Flood Assessment

Narwee Parklands Care Community

Prepared for Opal HealthCare c/o CYRE Projects / 03 July 2023

Response to SSDA Submission Comments

Figure 10 – PMF Levels Adjacent to Proposed Retaining Wall at Northern Site Boundary

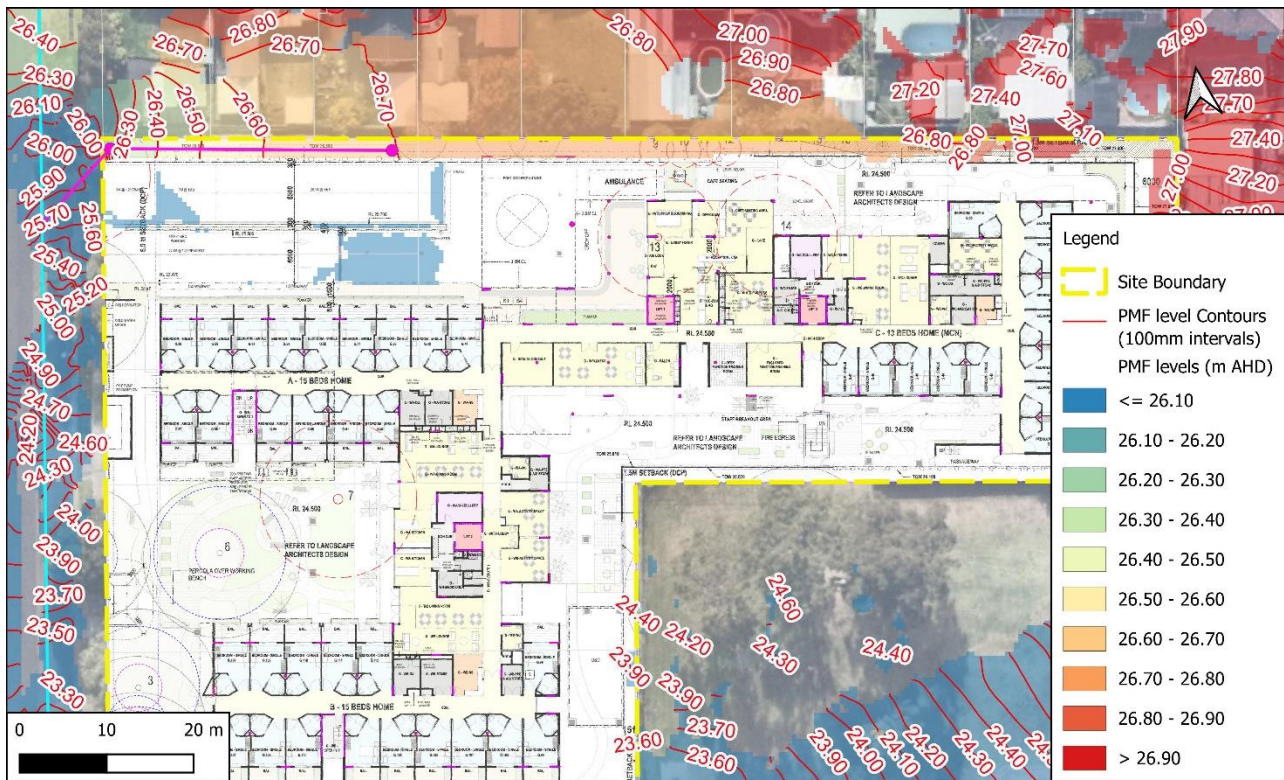
Agency / Organisation	Agency Reference	Comment from Agency / Organisation	Section Reference / Response
DPE	DOC23/109607	<p>The proponent should ensure the performance of retaining walls (such as reliability, stability and durability) under the PMF Event in order to eliminate any flood affectation at the basement of the building. Furthermore, a site emergency management plan should be developed by engaging a qualified professional to ensure the continuity of operations given the criticality and sensitivity of the proposed facility and its receptors under major flooding events including the PMF Event.</p>	<ul style="list-style-type: none"> ▪ The civil package considers draining flood waters such that it does not inundate the site. ▪ the proposed civil design package prepared by Henry & Hymas for the site effectively renders the site flood free during both 1% AEP and PMF events. Overland flows arriving from the northern site boundary are effectively redirected to Karne Avenue through the proposed retaining wall and drainage system at the northern boundary. ▪ The proposed retaining wall structure will be designed to withstand the forces of floodwater, debris and buoyancy up to and including the PMF (details to be provided by structural engineers at the detailed design stage). ▪ A Flood Risk Management Plan (FRMP) has been prepared for the site to provide recommendations to ensure that in the event of a flood, risk to personal safety is appropriately managed (Refer Section 8.0). ▪ The Flood Emergency Response Plan (FERP) also provides appropriate flood response strategies for the future site users (refer Section 8.3).

A retaining wall is proposed along the southern side of the drainage swale to ensure overland flows arriving from the northern site boundary will be contained within the proposed swale and would not overtop onto the site during all storm events up to and including the PMF.

Maximum PMF levels adjacent to the proposed retaining wall are shown in Figure 10. Please refer to relevant civil/structural drawings (Henry & Hymas) for the proposed retaining wall details.
